PREVOST

WARRANTY BULLETIN

WB23-45

DATE :	January 2024	SECTION :	06 ELECTRICAL
EXPIRATION:	January 2026		
SUBJECT :	ELECTRONIC GROUND STUD – CABLE 00 AND 00FR UNPROPERLY CONNECTED

FIGURE 2

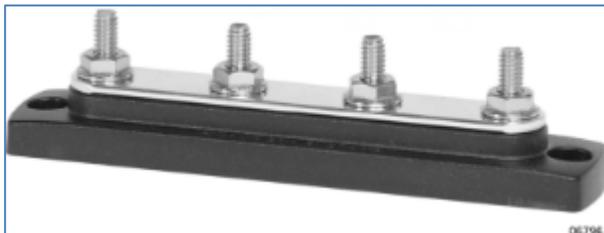
1. Open the main power compartment door. Locate the electronic ground terminal block.

FIGURE 3

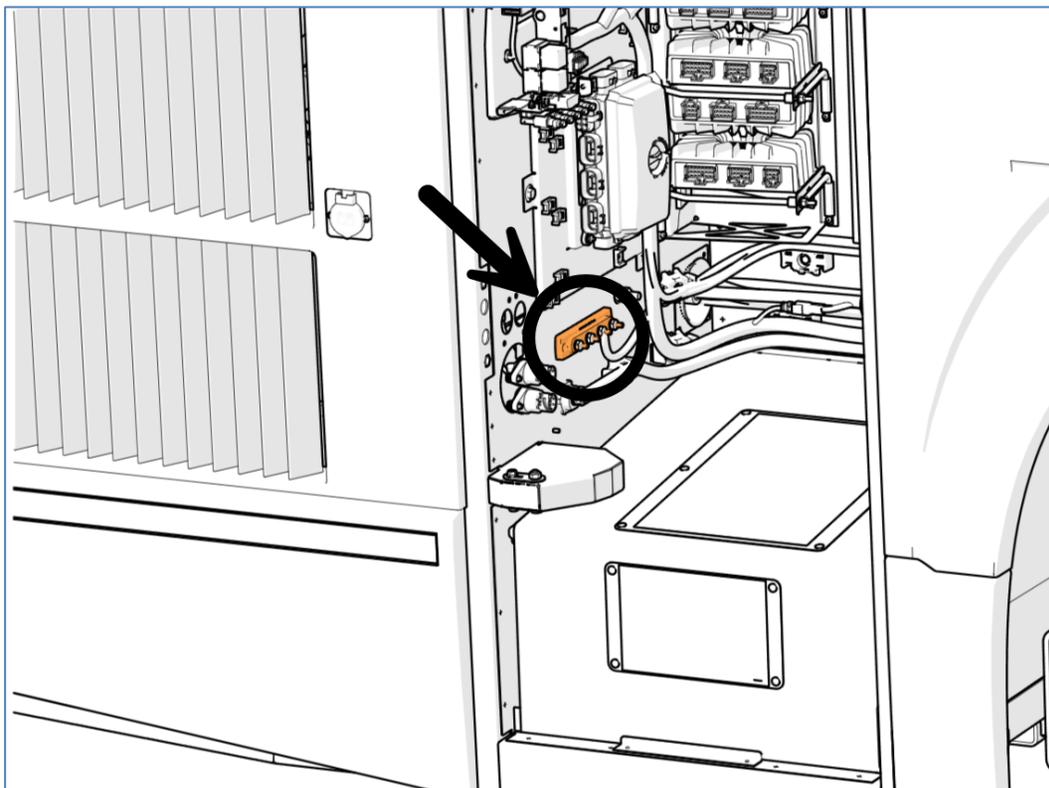
2. Check if the cable 00 flag terminal is secured in the proper order to the ground terminal block.
 - Cable 00 flag terminal must be installed first.
 - Cable 00FR terminal must be placed over cable 00 flag terminal.

FIGURE 6

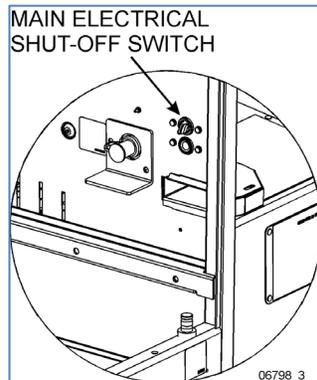
1. Set the main electrical shut-off switch to the OFF position.

FIGURE 7: MAIN CIRCUIT BREAKERS

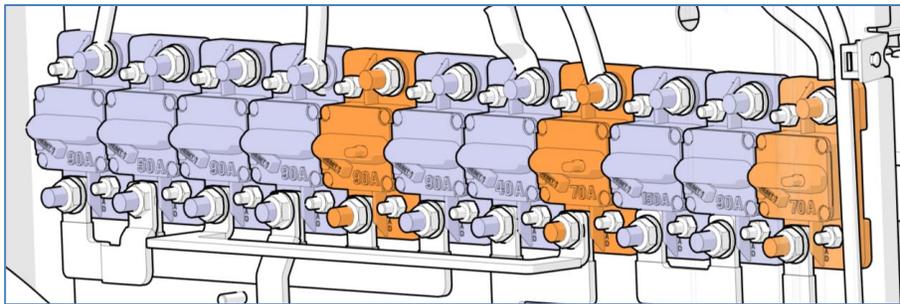
2. Trip all the main circuit breakers equipped with a manual trip button.

3. Remove both terminals from the terminal block stud.
4. Reinstall the terminals, placing cable 00 flag terminal fist, followed by cable 00FR terminal.
5. Fasten using a **new** NYRT nut p/n 5001251. Proper **torque** is 60 lbs-in.
6. Once tightened, apply Torque Seal mark.
7. Reset all open breakers to close the circuits.
8. Set the main electrical shut-off switch to the ON position.
